**Re: Audit of Verizon Communications (Verizon) Network in Riverside County Group**

**CPUC AUDIT FINDINGS OF  
VERIZON RIVERSIDE COUNTY GROUP  
SERVICE AREAS AUGUST 11-15, 2025**

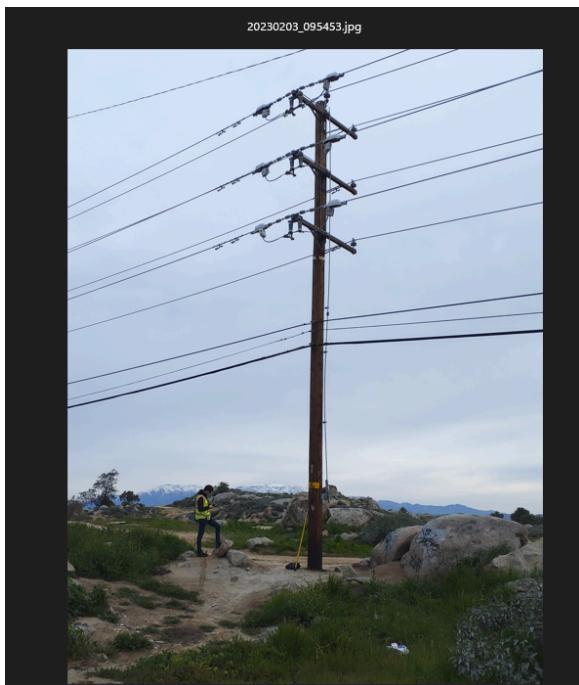
My staff discovered the following discrepancies between Verizon's pole loading records and conditions in the field:

- My staff observed that loading calculations by Verizon communication for Pole No. 1796632E was missing a secondary crossarm and a span guy at a height of 23.5 ft.

**Verizon Response:**

Verizon's loading calculations were accurate. The Verizon pole loading calculation was performed in 2023, and did not include the mentioned equipment, because the SCE cross arm and span guy were added after 2023. See attached photos (the first photo reflects the pole in 2023 when Verizon attached to it and the second photo with the red arrow shows the additions that were made subsequently in 2025).
